ECN/PCN No.: M1385
For Manufacturer

Product Description: Molded Power Inductor	Abracon Part Number / Part Series: ASPI-0520LR Series	<input type="checkbox"/> Documentation only <input checked="" type="checkbox"/> Series <input checked="" type="checkbox"/> ECN <input type="checkbox"/> Part Number(s) <input type="checkbox"/> EOL
Affected Revision: A	New Revision: B	Application: <input type="checkbox"/> Safety <input checked="" type="checkbox"/> Non-Safety

Prior to Change:
7.0 Mechanical Dimension

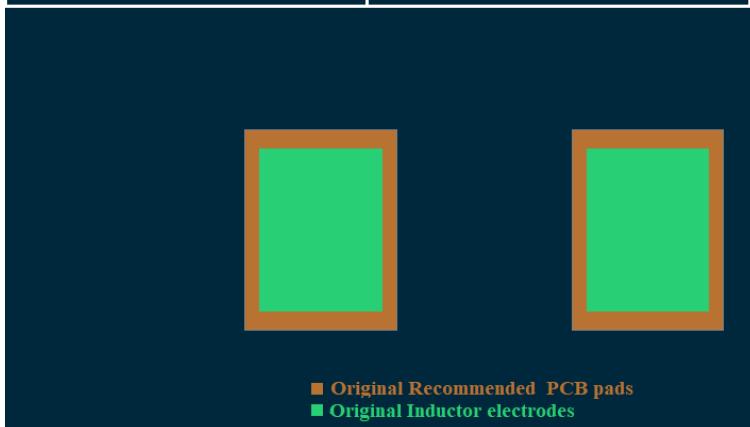
A	A'	B	B'	L	W	H
1.0 ±0.4	1.5 ±0.1	2.0 ±0.3	2.5 ±0.2	5.60 ±0.35	5.2 ±0.2	2.0 ±0.1

7.1 Recommended Land Pattern

Pad Analysis for the original recommended PCB pad layout and the inductors electrodes.

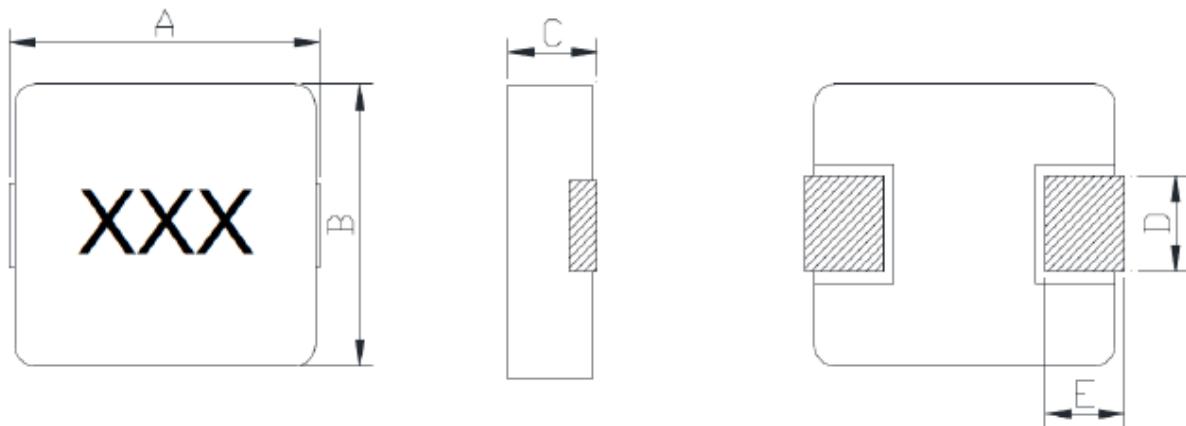
Inductor electrodes height:	2.0	PCB footprint pads height:	2.5
Inductor electrodes length:	5.6	PCB footprint pads length:	6
Inductor electrodes gap:	2.6	PCB footprint pads gap:	2.2
Enter a Scaling Value:	Dimensions [mm]		
<small>(Adjust value to zoom in or out, i.e 1.00, 0.5, 3.5..etc)</small>

Mechanical Specifications

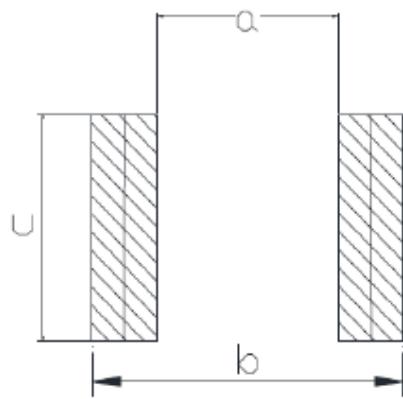
A	B	C	D	E
5.7 ± 0.3	5.3 ± 0.4	2.1 MAX	2.0 ± 0.5	1.2 ± 0.5

Recommended Layout

a	b	c
3.0 TYP	7.0 TYP	2.5 TYP

The overall mechanical outline has changed slightly. More importantly, the recommended pad layout has changed. Design engineers must review and ensure new pad dimensions are permittable. Please review the included pad dimension analysis illustrations.
